V2500-A1/A5/D5 PROPULSION SYSTEM SERVICE BULLETIN

This document transmits Revision 1 to Service Bulletin EV2500-73-0073

ENGINE FUEL AND CONTROL – ENGINE ALTERNATOR (STATOR) – INTRODUCTION OF AN INTEGRAL COOLING SHROUD

POWERPLANT - ENGINE DEDICATED ALTERNATOR (EDA) - MODIFICATION OF 430110 AND 430153 STATORS TO ACCOMMODATE AN INTEGRAL AIR SHROUD OR REPLACE WITH A NEW STATOR THAT INCORPORATES AN INTEGRAL AIR SHROUD

Family Tree
Fig.2

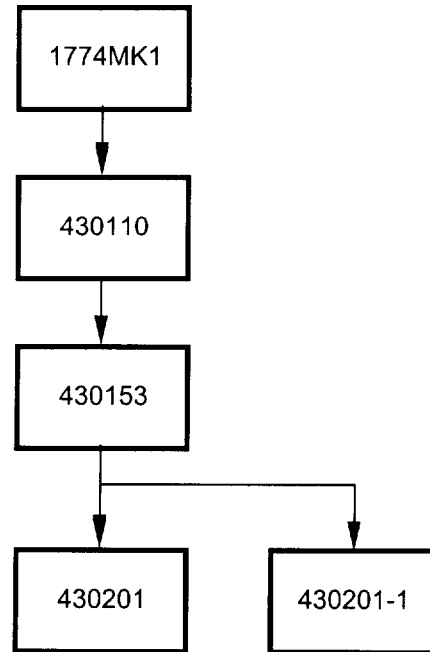
V2500-ENG-73-0073EDA - Introduction of an integral
cooling shroud

Family Tree
Fig.4

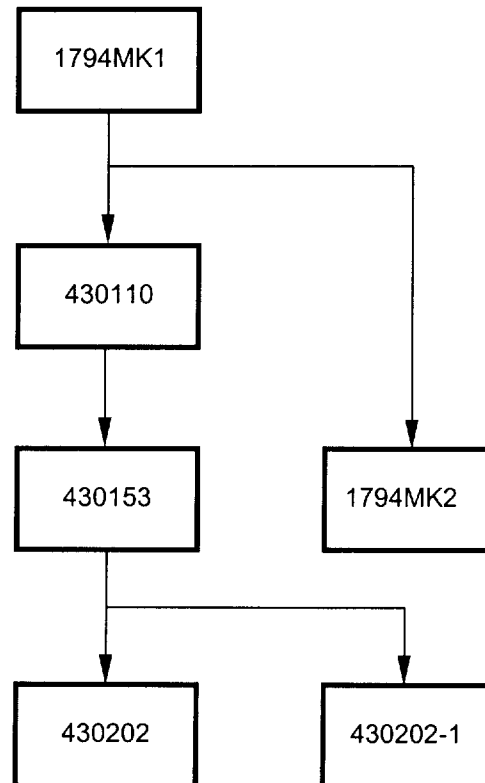
None**V2500-ENG-73-0070**EDA - New source of supply -
Unison Industries**None****V2500-ENG-73-0096**EDA - Introduction of new style
receptacles**None****V2500-ENG-73-0073**EDA - Introduction of an integral
cooling shroud**None**
